Job Name: **Land South of Westwells Road,
Corsham**

Job N°. **IMA-22-188**

Technical Note - Response to LHA Comments

Ref: PL/24/05527

Proposed Pedestrian Improvement
on Rowans Lane

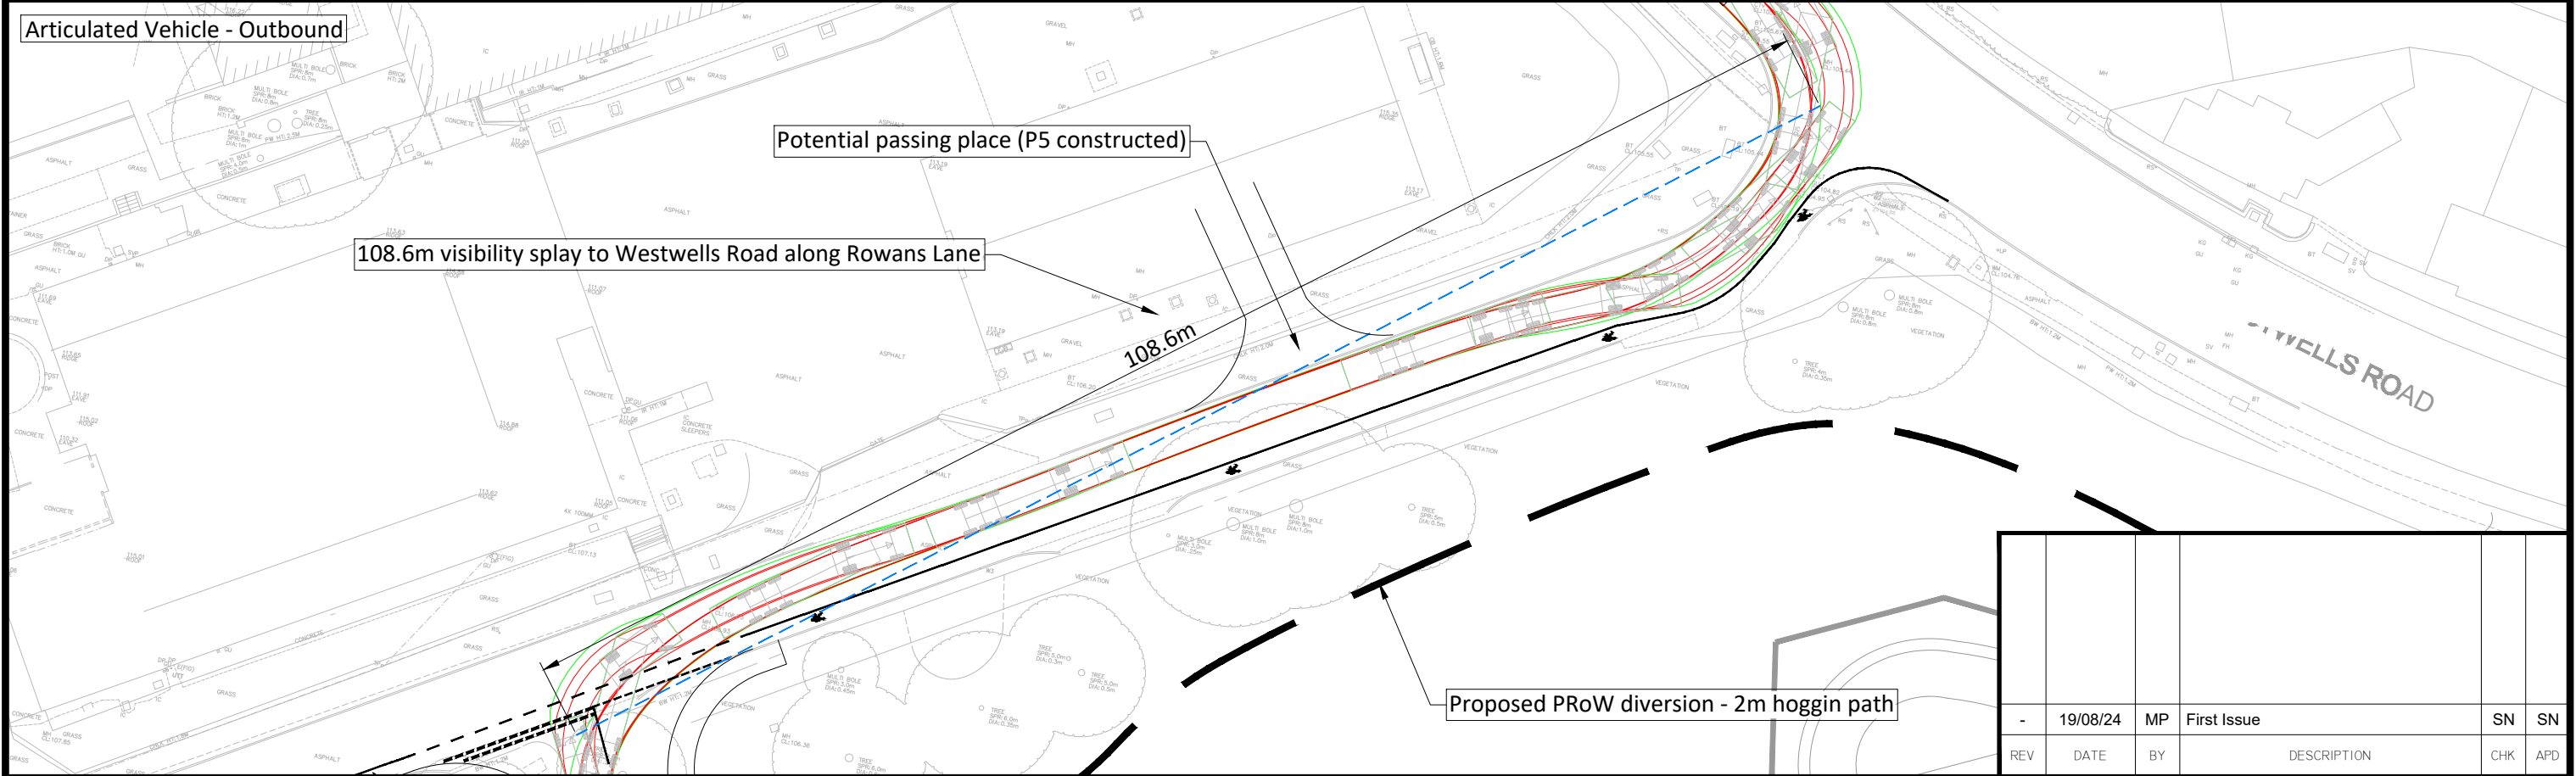
There are concerns relating to the junction of Rowan Lane with Westwells Road for the purposes of carrying movements associated with Heavy Goods Vehicles and conflicts that could arise with smaller private vehicles. The overall width and construction of Rowan Lane are a concern and do not appear to be sufficient for the carriage of larger vehicles. This does not appear to be addressed within the submission.

The proposed access point from the junction with Westwells Road to the site entrance need to be included as access for these proposals to ensure that the route is safe and suitable. There appears to be a lack of appropriate dedicated walking and cycling infrastructure on this route. The proposed white lined 1.2m wide pedestrian

lane, on carriageway would create direct conflicts for vulnerable road users and this is a matter that will need to be addressed to provide a more suitable facility.

- 3.6 Plan IMA-22-188-009 rev A shows the proposed pedestrian improvement on Rowan Lane, which is an extension of the existing white lined pedestrian route to the junction with Westwells Road, and has been updated to show the carriageway widths on Rowan Lane, the proposed pedestrian connection from Westwells Road and the diverted routes of PRoW which currently cross the site.

- 3.7 The proposed pedestrian connection to the application site from Westwells Road which connects to the diverted PRoW route running around the eastern side of the proposed data centre compound to the proposed footway at the site access from Rowan Lane, provides an alternative traffic free pedestrian route from Westwells Road to Rowan Lane to the west of the site access.

- 3.8 Between the proposed site access and the junction with Westwells Road, Rowan Lane is currently typically 6.1m wide and with the proposed provision of the 1.2m white lined pedestrian route the carriageway width would be reduced to 4.9m. Manual for Streets indicates that a 4.8m road width is sufficient for a car and large vehicle to pass, albeit on straight section of road and at slow speeds.

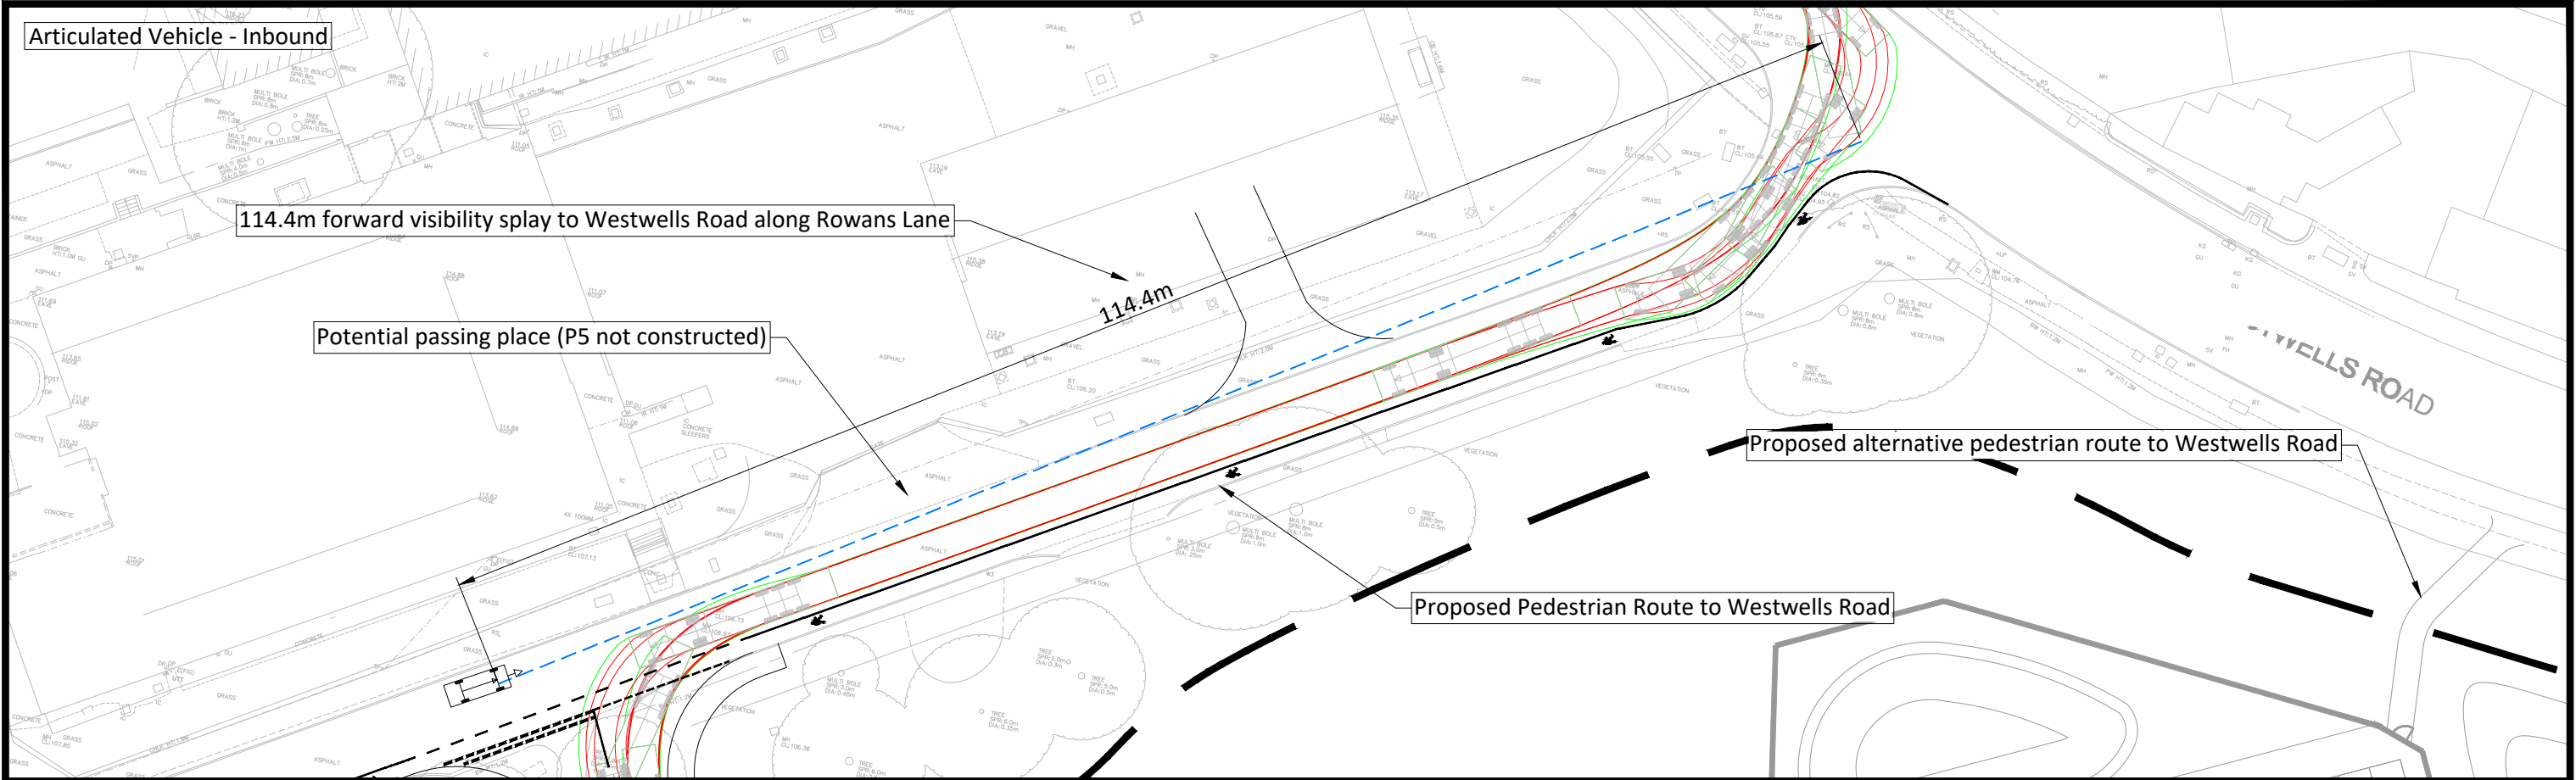
The swept path analysis presented shows HGV movements that take up the entire carriageway in near the Junction with Westwells Road and the site access that would create a conflict point with other more vulnerable road users.

Access – Demonstrate swept path and alterations to access junctions and routes for traffic. Provide infrastructure that removes conflict for most vulnerable road users. Improve technical specifications of Rowan Lane to be suitable for daily HGV passage.

- 3.9 Plan IMA-22-188-010 shows the swept vehicle path of a 16.5m articulated vehicle which is the largest vehicle expected to regularly visit the site, and shows that an articulated vehicle can turn in and out of Westwells Road, without having to cross the proposed pedestrian white line route.

- 3.10 As also shown on Plan IMA-22-188-010 there are clear sightlines from the proposed site access along Rowan Lane to the junction the Westwells Road, and that the existing access to the commercial units and the proposed emergency vehicle exit from the P5 South data centre onto Rowan Lane provide opportunities for vehicles to pass more easily.
